PIC16C65B Rev. A Silicon Errata Sheet

The PIC16C65B (Rev. A) parts you have received conform functionally to the Device Data Sheet (DS30605A), except for the anomalies described below.

FIGURE 1: $\overline{\text{MCLR}}$ EXTERNAL CIRCUIT

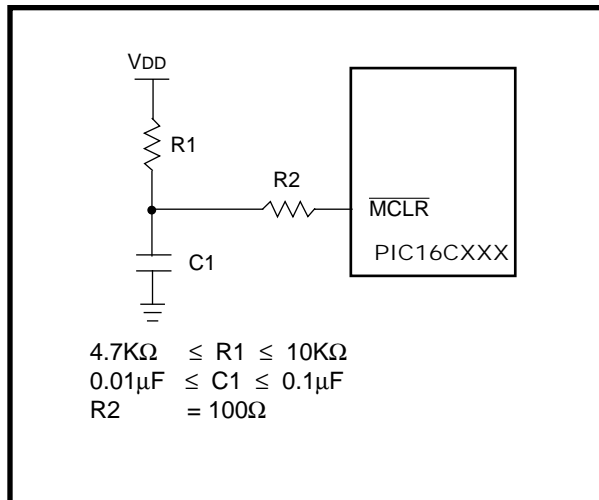
The minimum specification for the $\overline{\text{MCLR}}$ must be met in order to RESET the PIC16CXXX. If a $\overline{\text{MCLR}}$ pulse occurs that is less than the minimum specification (parameter #30), improper device operation can occur.

If the Minimum specification cannot be met, then an external circuit must be used to insure that any pulse width less than the specification will be filtered before it reaches the $\overline{\text{MCLR}}$ pin.

A possible circuit is shown in Figure 1. Proper design validation needs to be done to ensure desired operation over the applications operating conditions

Figure 1: Wake-up from Sleep

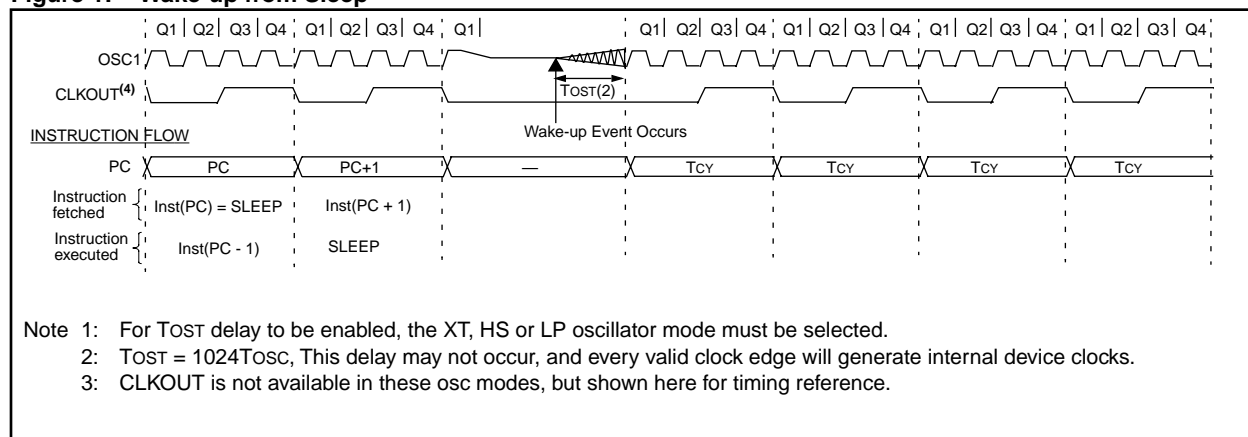
The Oscillator Start-up Timer (TOST) delay may not occur when the device wakes-up from sleep.

Figure 1 shows the start-up of the crystal after the event that causes the device to wake up from sleep mode (as specified in device data sheet). The start-up time (TOST) may not occur.

In applications where time based measurements are started immediately after wake-up from sleep, the suggested work around should be implemented.

After the SLEEP instruction, do a software delay of 256 Tcy (same as 1024 TOSC). At the Reset and Interrupt vector addresses, test to see if the device woke from sleep (the $\overline{\text{TO}}$ and $\overline{\text{PD}}$ bits), and if the device did wake from sleep, ensure that the total cycle delay is 256 Tcy.
